<b>Well Name:</b> DICK & DONNA 2729 FED COM	<b>Well Location:</b> T22S / R28E / SEC 26 / SWNW / 32.366251 / -104.062839	<b>County or Parish/State:</b> EDDY / NM
<b>Well Number:</b> 201H	<b>Type of Well:</b> OIL WELL	<b>Allottee or Tribe Name:</b>
<b>Lease Number:</b> NMNM19842A	<b>Unit or CA Name:</b>	<b>Unit or CA Number:</b>
<b>US Well Number:</b> 3001557512	<b>Operator:</b> MATADOR PRODUCTION COMPANY

**Notice of Intent**

**Type of Action:** APD Change

### Sundry Request

## Casing Specs - 7-5/8" 29.7lb MO-FXL

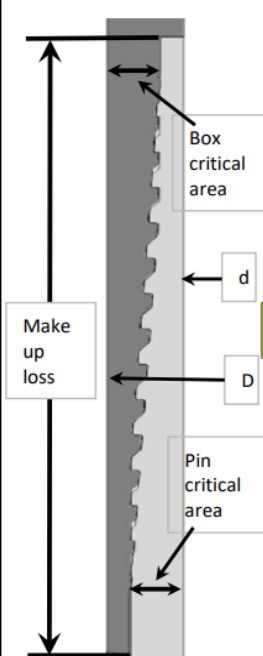
- Option to drill intermediate hole size of 8-3/4" OH
- Option to run intermediate casing type of 7-5/8" MO-FXL
- Cement volumes will be adjusted accordingly to reflect change of intermediate hole size

**Note:** This confirms that the operator is approved to drill an 8-3/4" hole for the intermediate section and run 7-5/8" casing with MO-FXL flush joints. Adjust cement accordingly.
